# **87C196JQ SPECIFICATION UPDATE**

Release Date: January, 1997

Order Number: 272857-002

The 87C196JQ may contain design defects or errors known as errata. Characterized errata that may cause the 87C196JQ's behavior to deviate from published specifications are documented in this specification update.

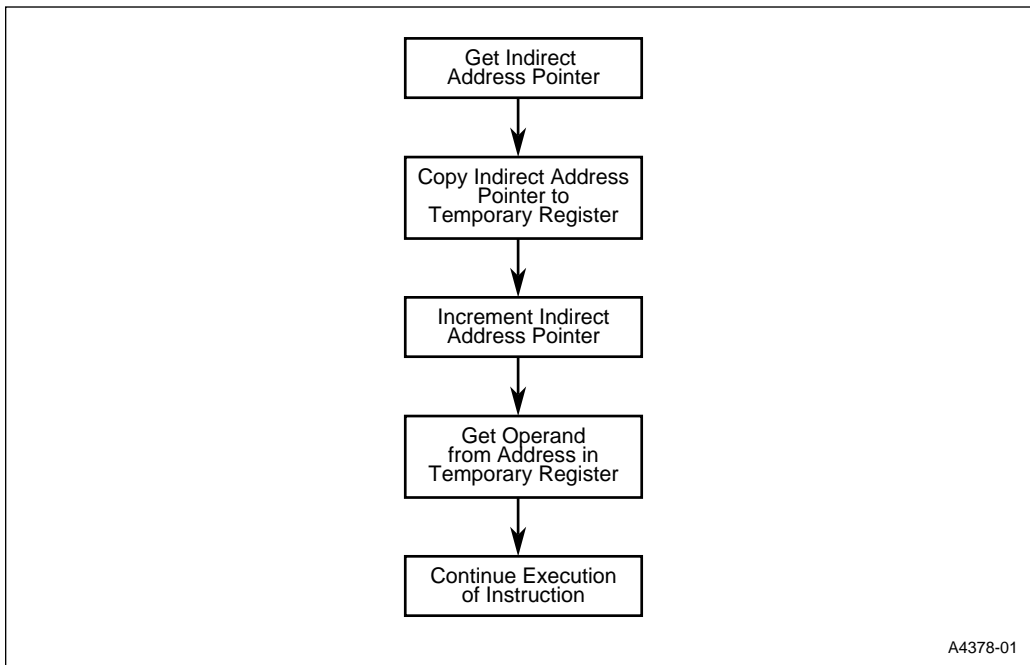
**PROBLEM:** The EPA can lock up if overruns are handled incorrectly. Overruns occur when an EPA input transitions at a rate that cannot be handled by the EPA interrupt service routine. If no overrun handling strategy is in place, and if the following three conditions exist, a situation may occur where both the capture buffer and the EPAX\_TIME register contain data, and no EPA interrupt pending bit is set:

- an input signal with a frequency high enough to cause overruns is present on an enabled EPA pin, and
- the overwrite bit is set (EPAX\_CON.0 = 1; old data is overwritten on overrun), and
- the EPAX\_TIME register is read at the exact instant that the EPA recognizes the captured edge as valid.

The input frequency at which this occurs depends on the length of the interrupt service routine as well as other factors. Unless the interrupt service routine includes a check for overruns, this situation will remain the same until the device is reset or the EPAX\_TIME register is read. The act of reading EPAX\_TIME allows the buffered time value to be moved into EPAX\_TIME. This clears the buffer and allows another event to be captured. Remember that the act of transferring the buffer contents to the EPAX\_TIME register is what actually sets the EPAX interrupt pending bit and generates the interrupt.

**WORKAROUND:** Any one of the following methods can be used to prevent or recover from an EPA overrun situation.

- Check for pending EPAX interrupts before exiting an EPAX ISR

Another method for avoiding this situation is to check for pending EPA interrupts before exiting the EPA interrupt service routine. This is an easy way to detect overruns and additional interrupts. It can also save loop time by eliminating the latency necessary to service the pending interrupt. However, this method cannot be used with the peripheral transaction server (PTS).

**Figure 1. 16-bit System with EPROM**

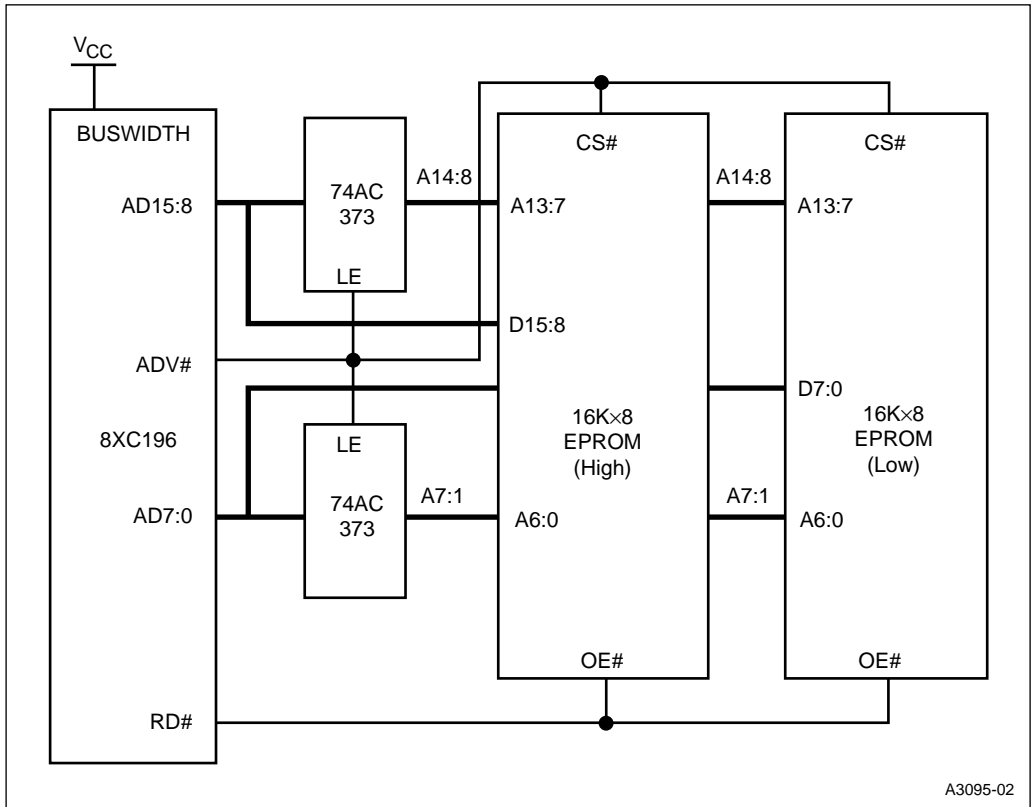
**001.** *High address inputs to the low EPROM should be A14:8 in Figure 15-18.*

**ITEM:** The next revision of the user's manual will include the following corrected graphic.
